**GEAR CASE COVER OIL RELIEF HOLE / 1970 ELECTRA GLIDE**

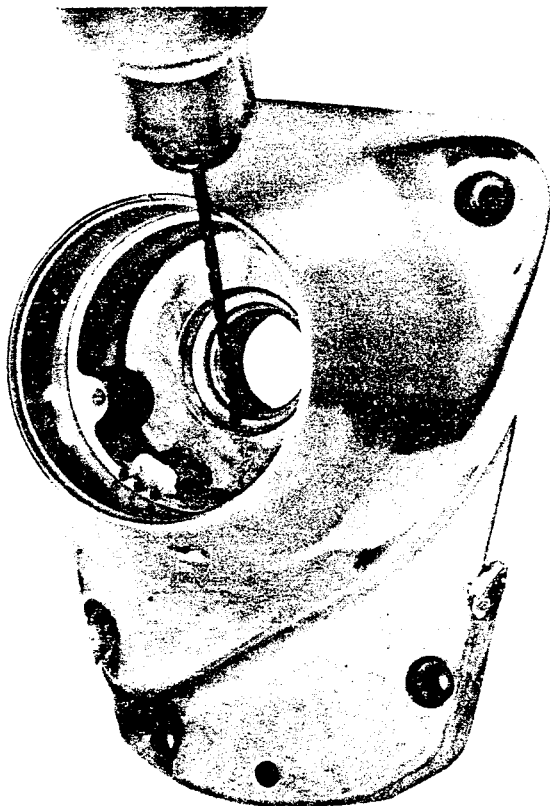
Starting with Electra Glide engine serial No. 12974, a hole has been added through the gear case cover flywheel shaft bushing boss to relieve possible pressure buildup in the pocket between the bushing and seal. In some cases, oil pressure buildup has caused leakage into the circuit breaker compartment or has blown out the lip type seal.

Drill 1/8 dia. oil drain hole.

If desired, the oil hole can be drilled in gear case covers of engines below serial No. 12974 as follows: Remove circuit breaker cam bolt, breaker plate, advance assembly and gear case cover from engine. Remove oil seal from cover using a puller, or prying it out of recess. (A new seal must be installed when parts are reassembled.) Center punch and drill a 1/8 diameter hole through the aluminum boss, as shown in the illustration. Note that the hole should be located between the bushing and the seal. It should come out on the outside of the boss so that any accumulation of oil can drain from the recess between the seal and the bushing, then back into the gear case compartment. Install new oil seal and reassemble cover and circuit breaker on engine.

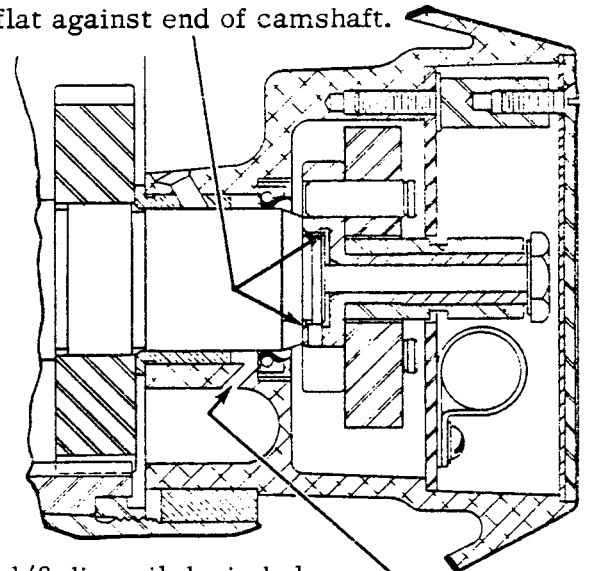
Set ignition timing according to procedure in Owner's Manual. Be sure to check circuit breaker point gap on BOTH cam lobes. If variation exceeds .002 in., correction must be made by checking for proper assembly of parts. Check advance plate assembly, Part No. 32629-70, for correct seating on end of camshaft. Interference between this part and camshaft end will cause the cam to tilt when center bolt is tightened resulting in unequal point gap. Correct by replacing plate or repair plate to provide necessary clearance as shown in the illustration below.

Chamfer edge and remove burrs from inside of recess in plate. Plate must seat flat against end of camshaft.
